Final Drainage Report

**Nabulsi-
Abushaban
Subdivision**

Project No. 61201

PCD File No. **"MS2211"**

EXCLUDED PER ECM I.7.1.B.5

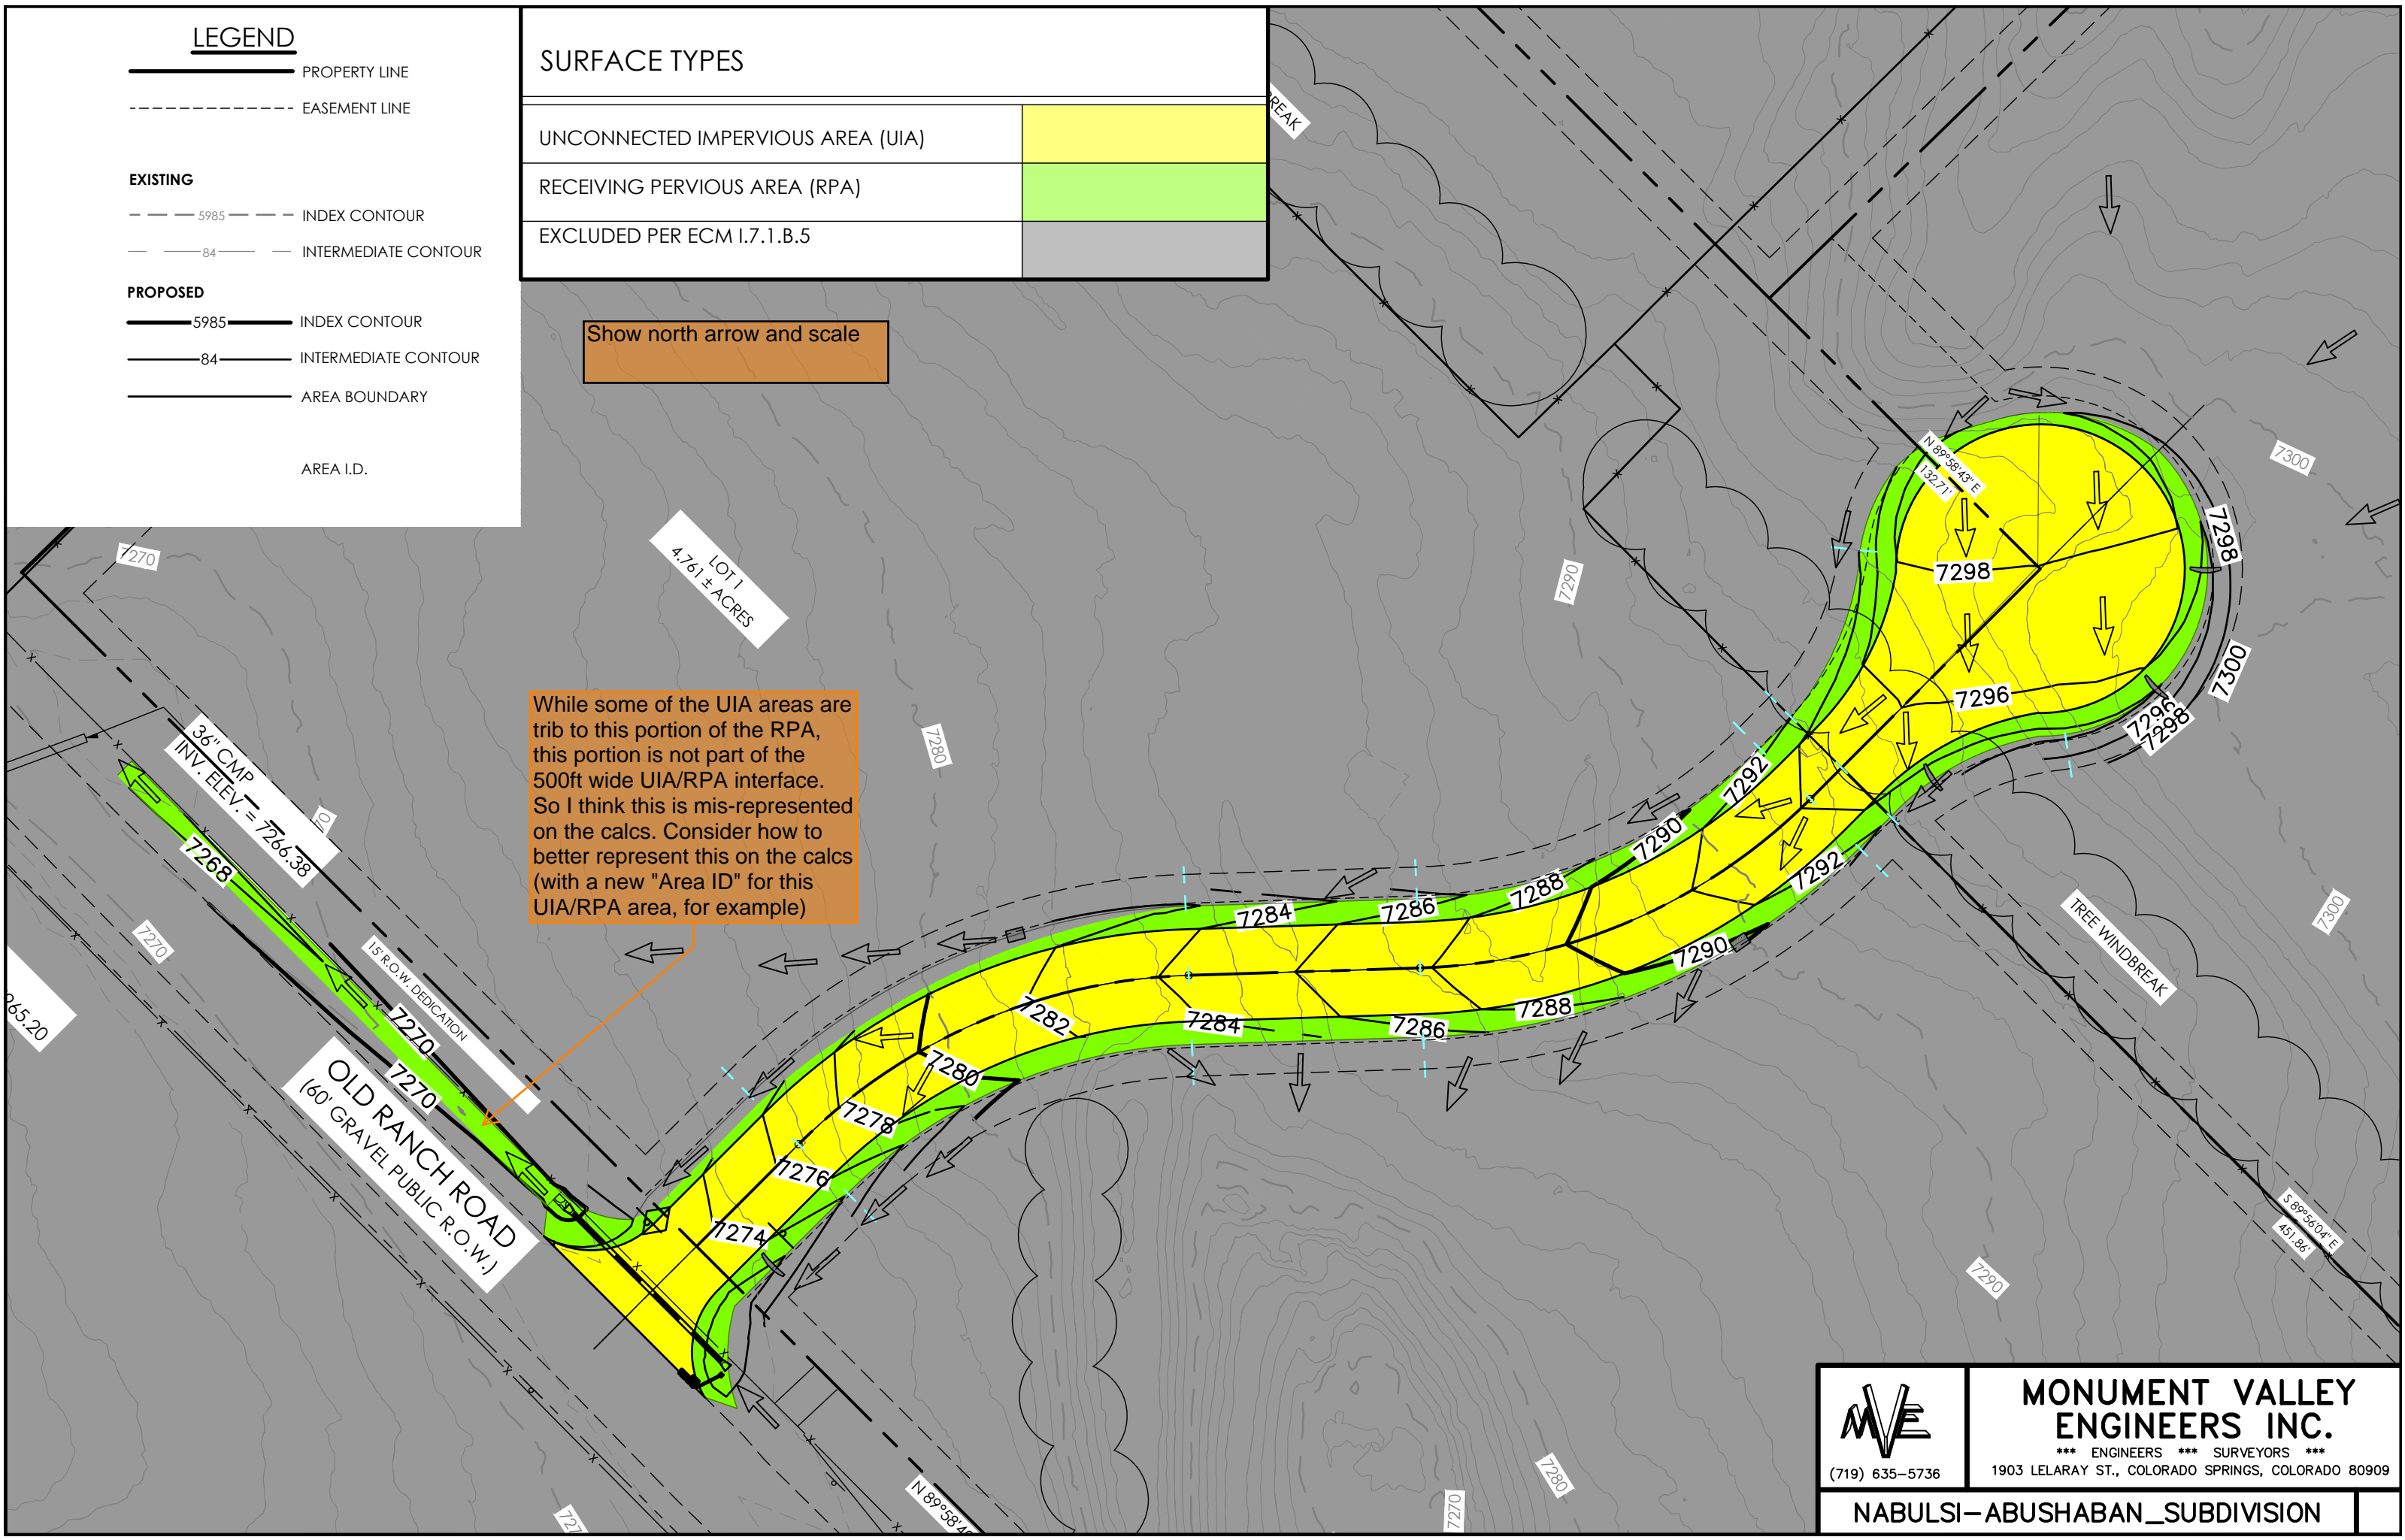
I assume that these two areas are related to Basins A2 and B1 but please label and delineate these areas on the RR map below for clarity.

Show north arrow and scale

While some of the UIA areas are trib to this portion of the RPA, this portion is not part of the 500ft wide UIA/RPA interface. So I think this is mis-represented on the calcs. Consider how to better represent this on the calcs (with a new "Area ID" for this UIA/RPA area, for example)

MVE PROJECT: **61201**
MVE DRAWING: **PP-DRN**

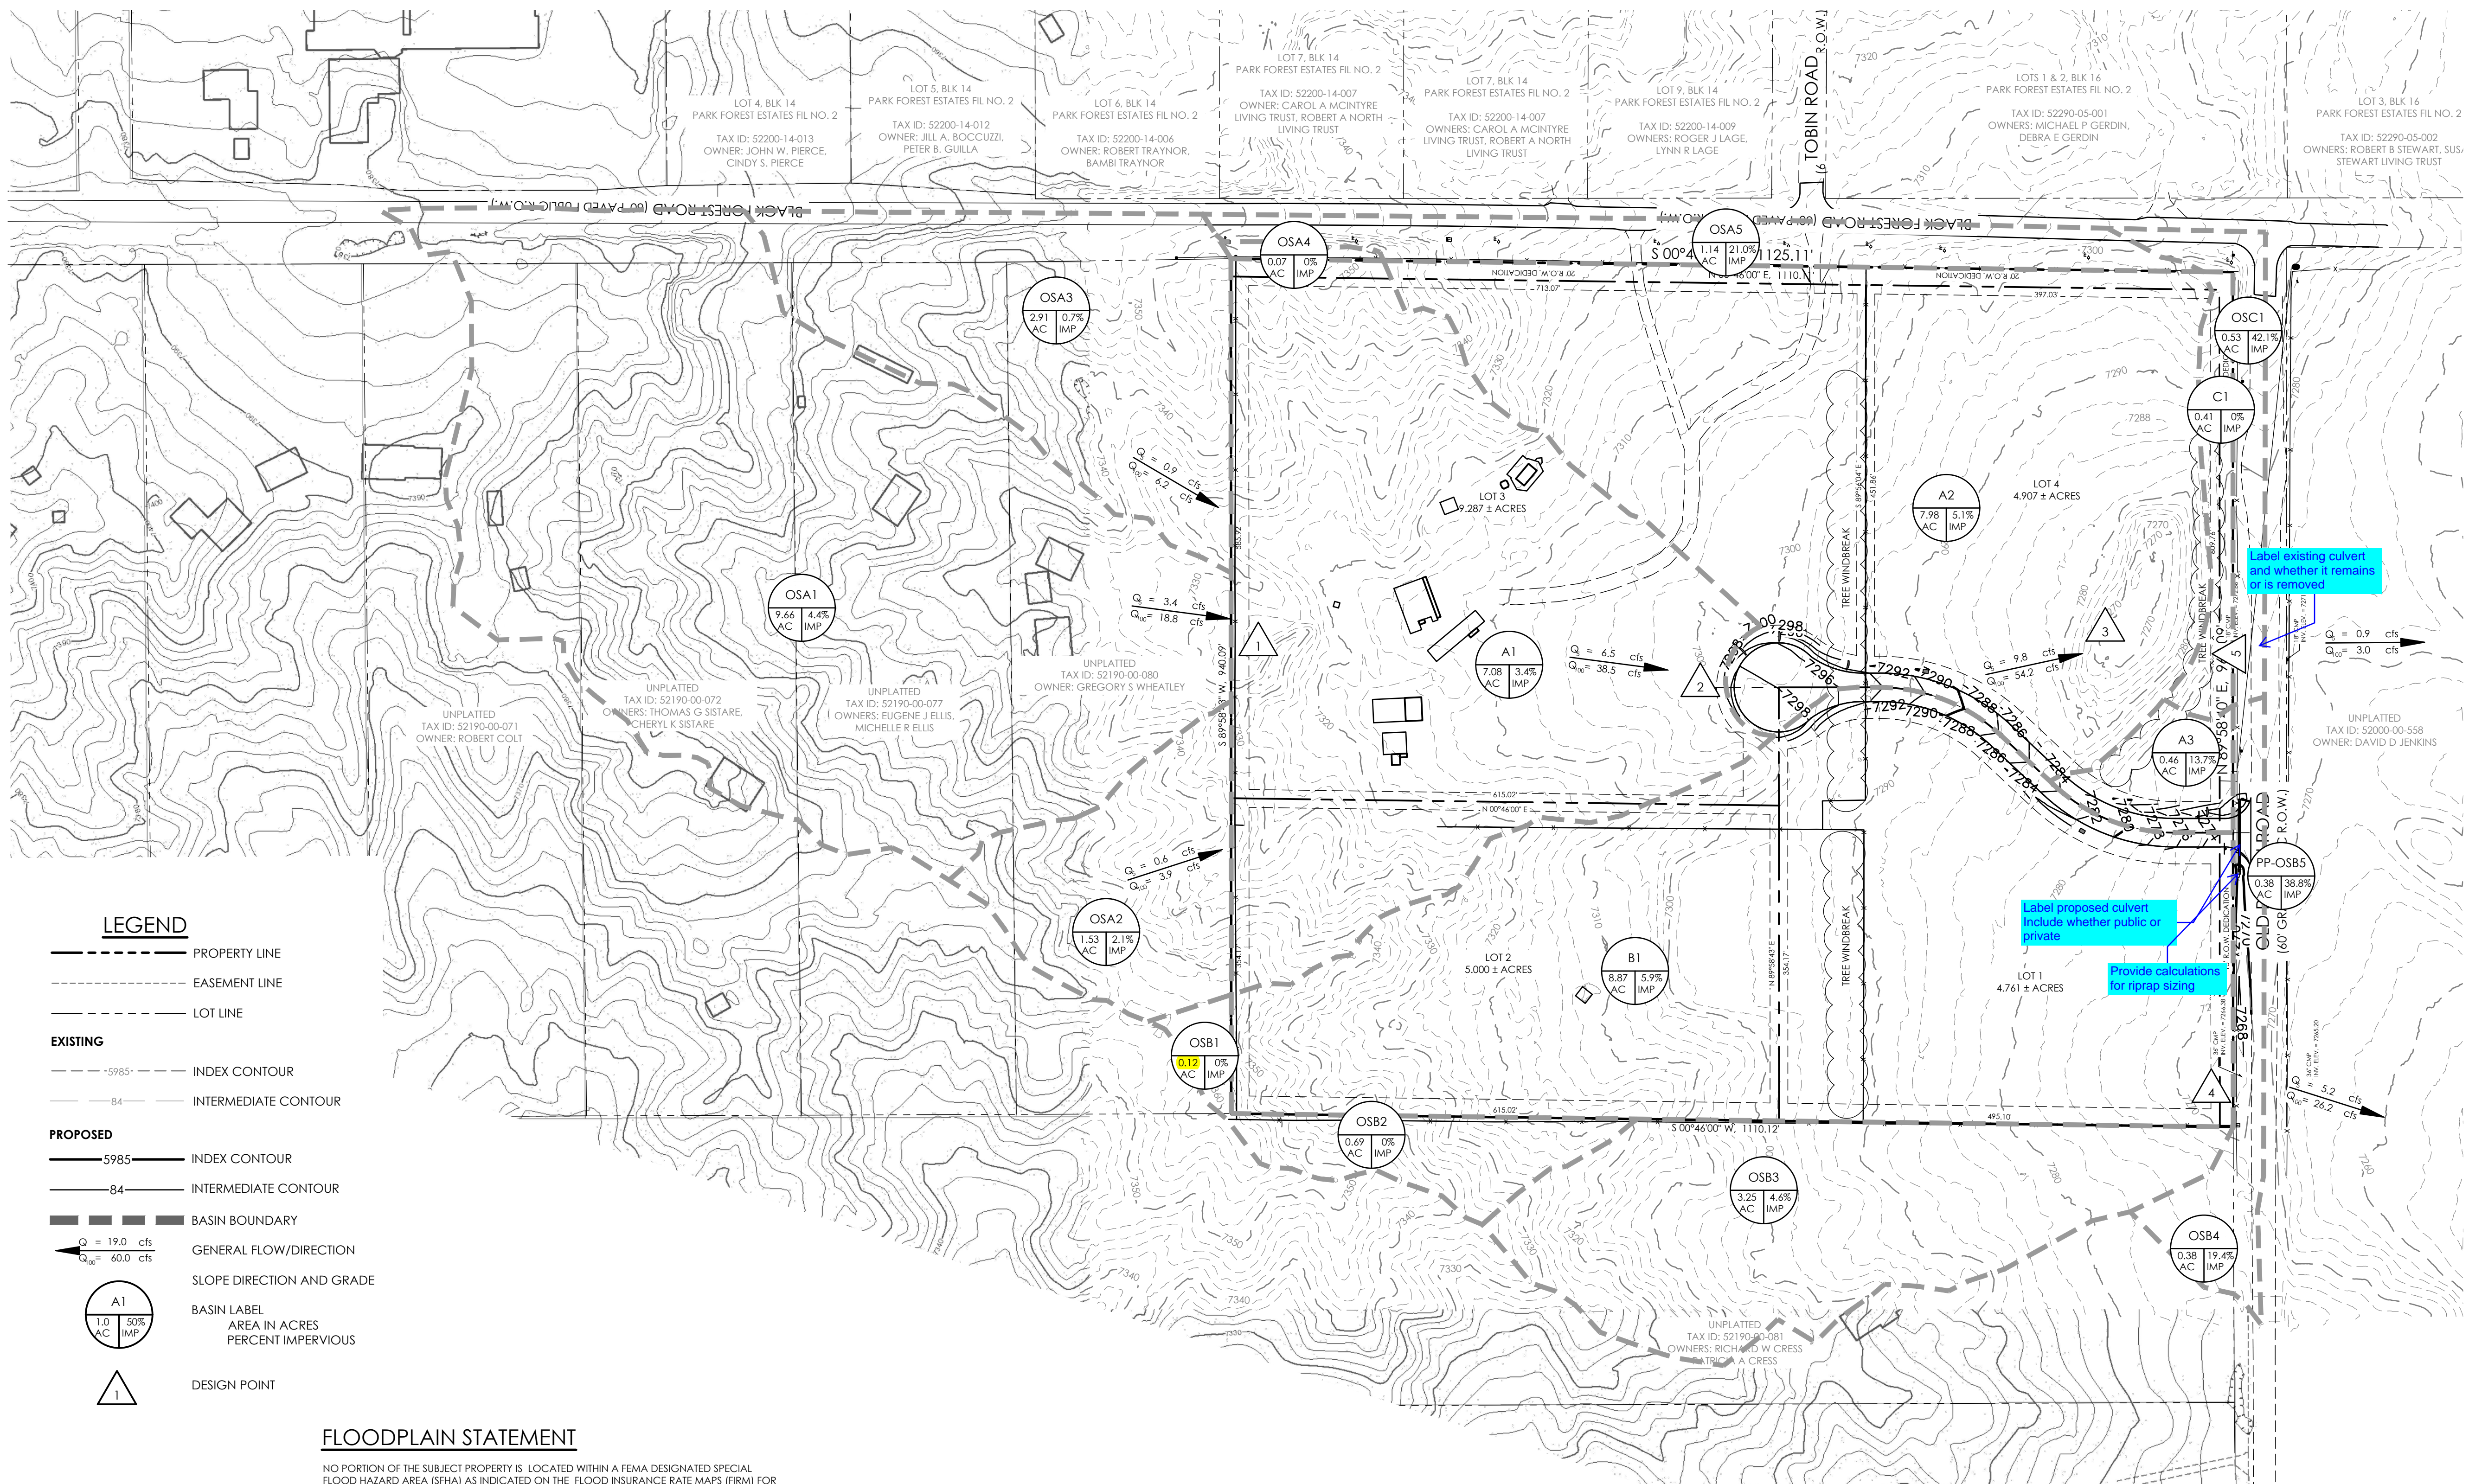
Area does not match with hydrology spreadsheets

Remove this line since basin is not on this map
